**Subject:** RE: Additional Information Request for AN 659726-7 ID 119219 Chiquita Canyon Landfill

I have been assigned the applications (ANs 659726-7) submitted for Chiquita Canyon Landfill (ID 119219) for the modification of landfill gas condensate and leachate collection/storage system. I have reviewed the provided information and have determined that additional information is required. Pursuant to Rule 210, the application(s) may be denied if the necessary additional information is not submitted. Please provide the following information by **June 11, 2025**, so I may proceed with processing these applications:

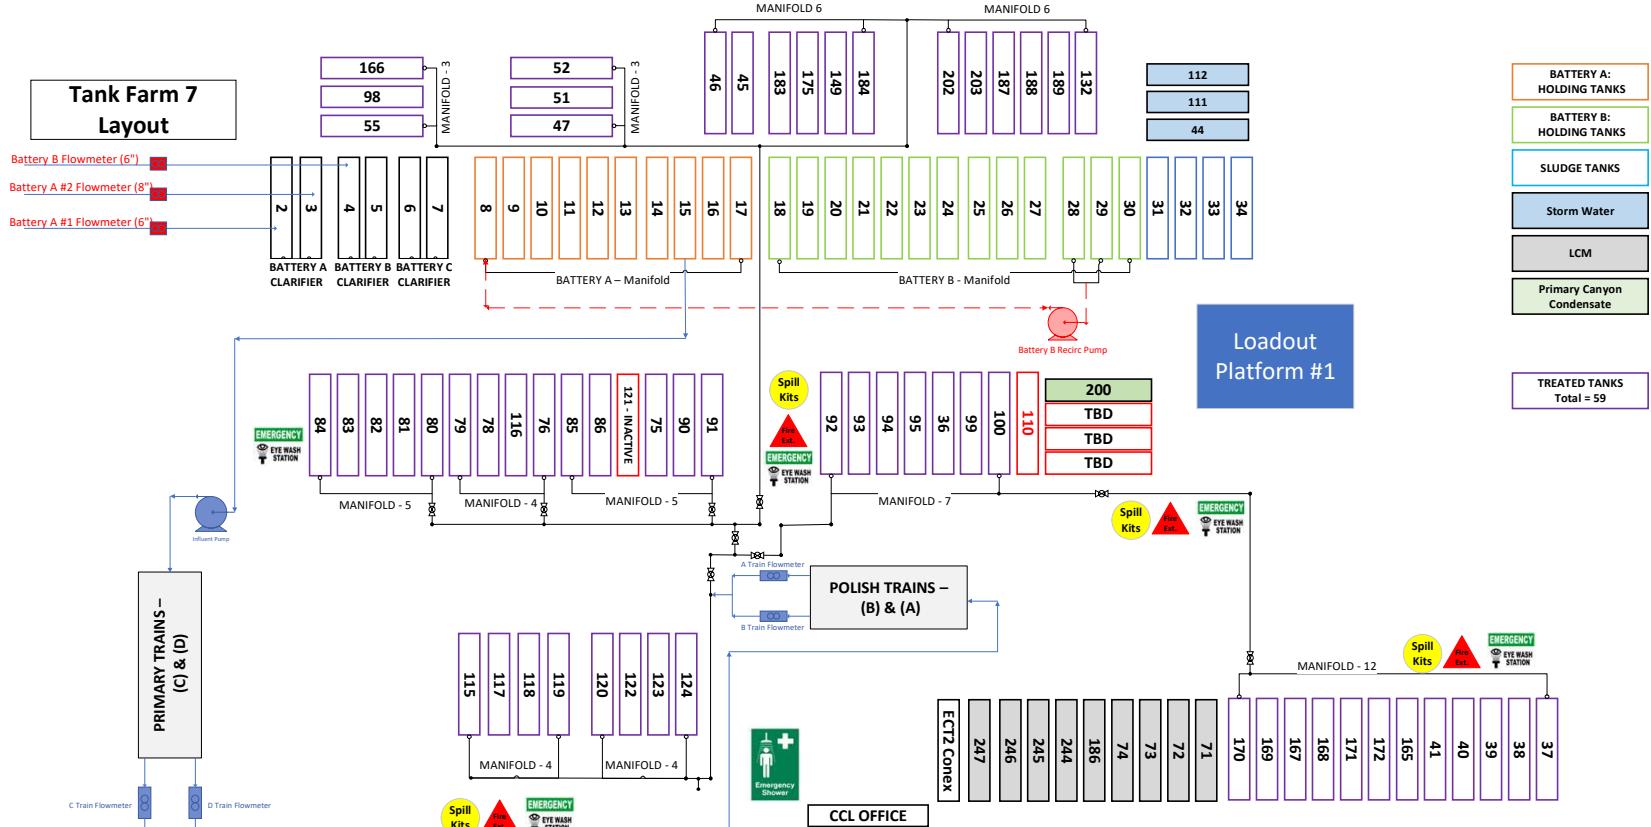
7. Provide a diagram/map showing how leachate flows to each tank farm. Specifically, does each tank farm collect leachate from a designated portion of the landfill? **See attached ".png" files and pdfs "TF7 Layout", "TF9 Layout", "Canyon D Tank Farm Layout", and "Tank Map".**
